APPARATUS AFFECTED: 1A and 2A Tape Readers — DATASPEED.

**TP149989 BRACKET
AND TP149990 NUT PLATE**

NOTIFICATION OF CHANGE IN TELETYPE APPARATUS
TP125258 COILED EXTENSION SPRING

SENSING FINGER SPRING TENSION REQUIREMENT

Figure 1

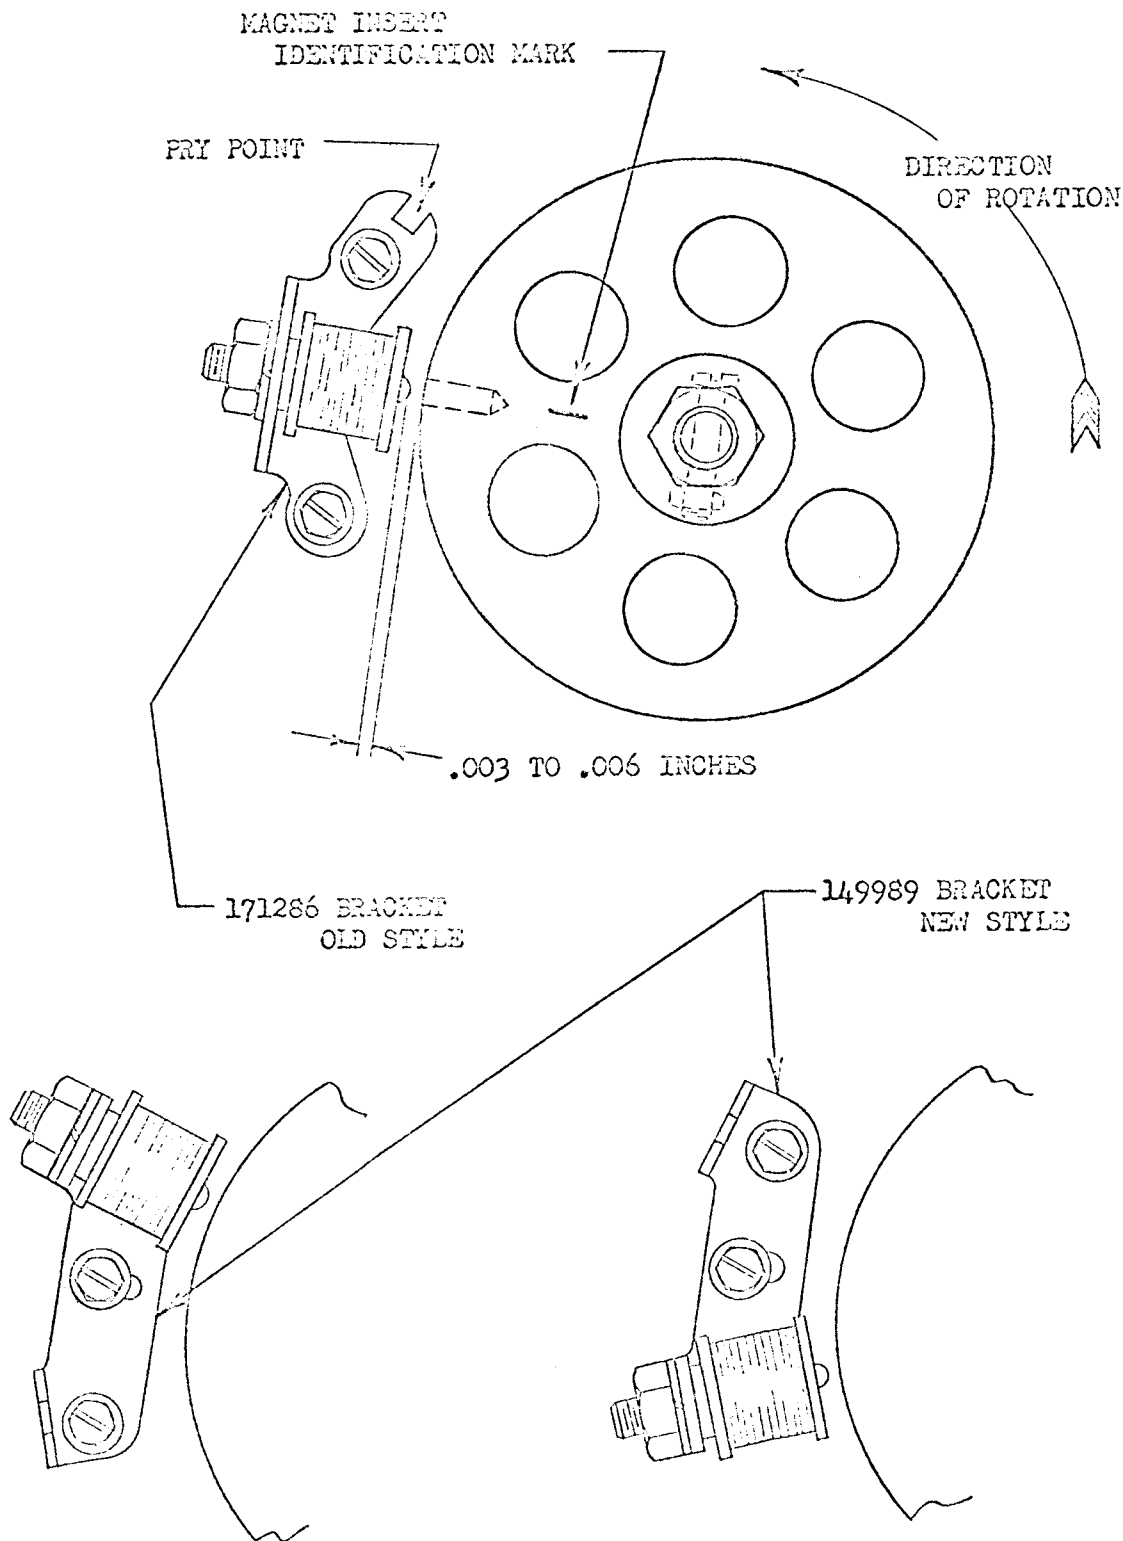
CHANGE: The TP171285 nut plate and TP171286 coil mounting bracket have been replaced by a TP149990 nut plate and a TP149989 coil mounting bracket.

The new style TP149989 coil mounting bracket has two formed ear sections to which the 261M coil assembly can be mounted and each ear is about 19 degrees from the bracket center line. The pickup coil may be optionally mounted on either of the coil mounting ear sections. The added 19 degree displacement of the coil position will enable establishing an orientation overlap of the pickup coil relative to the insert of the flywheel at either the leading or trailing end of the transmitted signal.

The new style TP149990 nut plate has an over-all length of about 13/16 (.818) inches. The old style TP171285 nut plate has an over-all length of about 1-1/4 (1.251) inches.

Figure 1 illustrates the old and new style brackets. The new style bracket requires the addition of preliminary assembly information to the bulletins and practices which are as follows:

Add to (2) Requirement, after To Adjust, this "Note":

"For units equipped with the TP149989 coil mounting bracket, it may be necessary to mount the pickup coil on either the upper or lower mounting ear to obtain an orientation overlap."
